# Oconee Flood Protection and the 10 CFR 50.54(f) Response

## Background Material

10/3/2012

## Flood Analysis for Oconee Nuclear Station.

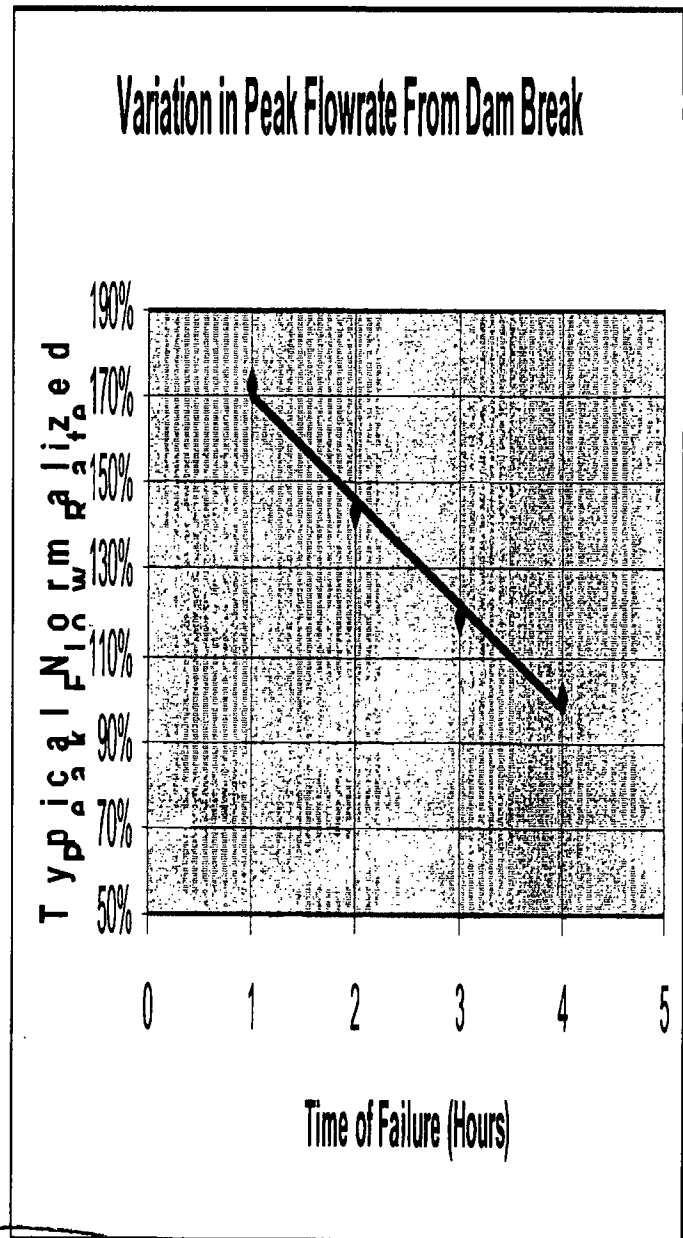
Two dimensional (Depth Averaged) hydraulic models allow for modeling unusual flow patterns over complex topography. Two-dimensional models are applicable under the following circumstances

- Flow varies in 2 dimensions
- Cross-stream
- Circulations
- Split flow around objects or topography
- Complex floodplains

Two-dimensional models are capable of investigating areas near submerged structures and over complex topography.

Since the topography in the immediate vicinity of the ONS is complex and in close proximity of the Keowee dam a two-dimensional model is needed to adequately represent the complex flow at the site.
